Palo Verde Nuclear  
Generating Station

**Subject: Palo Verde Nuclear Generating Station (PVNGS)  
Unit 2  
Docket No. STN 50-529  
Request for Amendment to Technical Specification 3.5.5, Refueling  
Water Tank (RWT), to Increase the RWT Minimum Water Level for  
Unit 2 Under Exigent Circumstances**

Subject: **Request for Amendment to Technical Specification 3.5.5, Refueling Water Tank (RWT), to Increase the RWT Minimum Water Level for Unit 2 Under Exigent Circumstances**

FIGURE 3.5.5-1  
Minimum Required RWT Volume

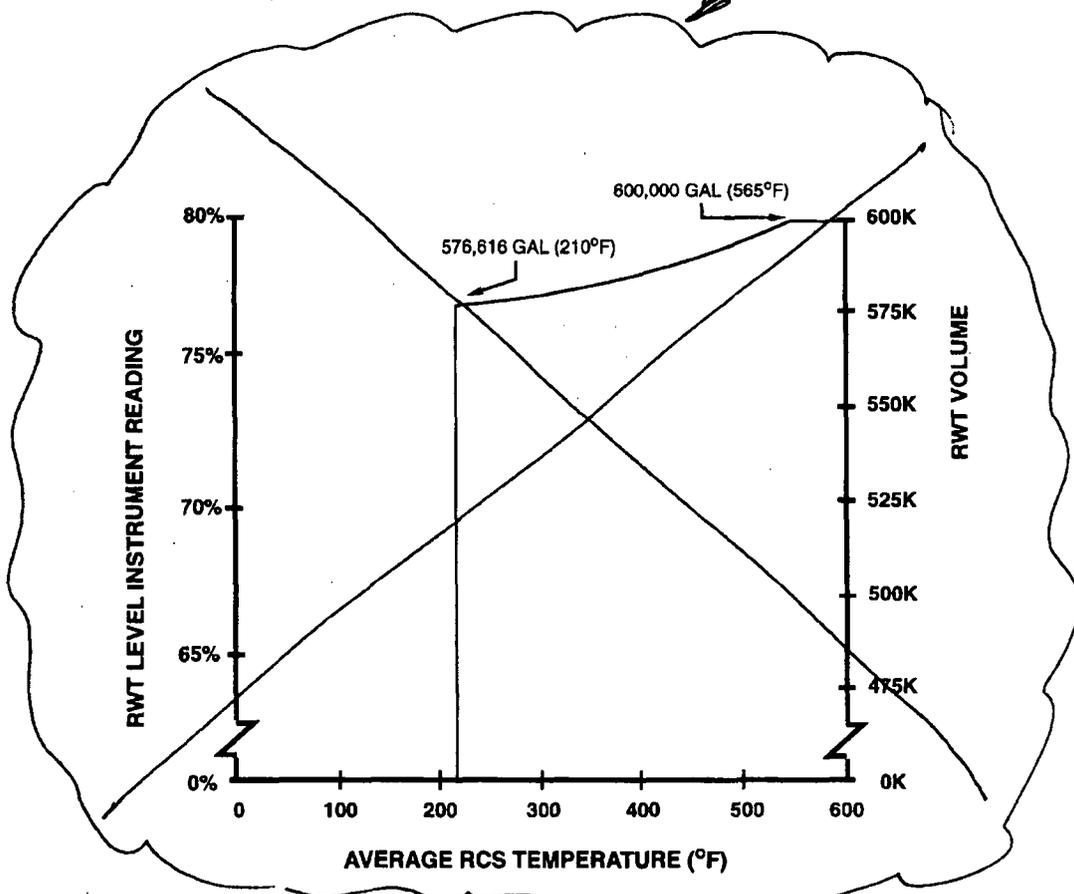
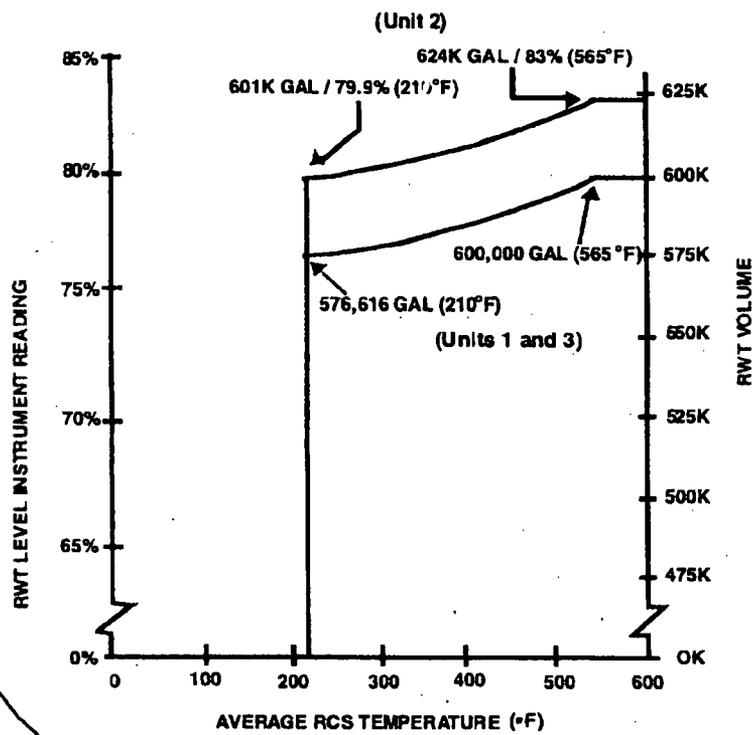
The proposed amendment would modify technical specification (TS) 3.5.5, Refueling Water Tank (RWT), to increase the minimum required RWT level indications and the corresponding borated water volumes in TS Figure 3.5.5-1 for Unit 2 by 3%. This change will ensure that there is adequate water volume available in the RWT to ensure that the engineered safety feature (ESF) pumps and the new containment recirculation sump strainers will meet their design functions during loss of coolant accidents (LOCAs).

The proposed amendment would revise TS 3.5.5 to raise the required minimum RWT level indications and the corresponding water volume values shown in Figure 3.5.5-1 by 3%. This change revises the minimum level indications and the corresponding water volumes used to determine operability of the RWT from 210 °F through 600 °F (i.e., to ensure that there is adequate volume available for the design functions of the RWT). This change will ensure that there is adequate water volume in the containment to meet the functional requirements of the ESF pumps and the containment sump strainers for applicable design basis accidents and break scenarios.

*Replace with Attached Figure*

Replacement Figure For Figure 3.5.5-1
